Re: North Campus Facilities

Subj: Change Proposal No. 233901-0018

We respectfully submit our proposal for an increase to our contract in the amount of \$0 (zero) dollars to provide Field Modifications to Wall and X Bracing due to RFI 135 for the above referenced project.

RFI NO: 135

Drawing Number: Ah-2.01, Sh-2.01

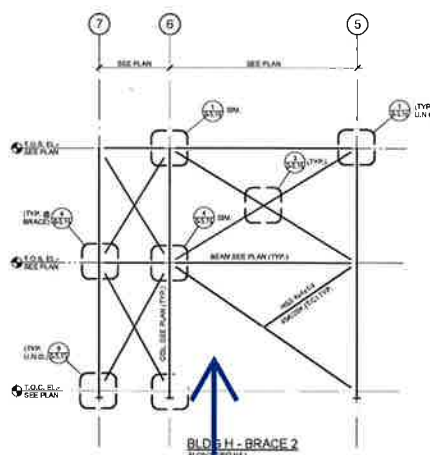
Sh-2.01 shows an X Brace along column line 4 between Rooms h103, h105 and h104. The X Brace is in conflict with the h104 Door and also with the Type B1 wall that is a 4" stud wall with 1 layer of gypsum on each side.

Please advise on the door and X Bracing fitting in the wall at this location.

Change wall from type H1 to S1  
BH 6/16/17

Delete HSS brace  
segments as indicated

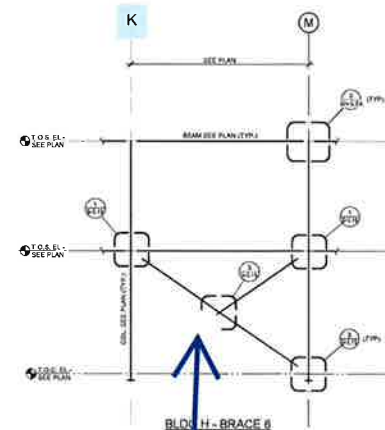
delete HSS brace  
here

delete HSS brace  
here
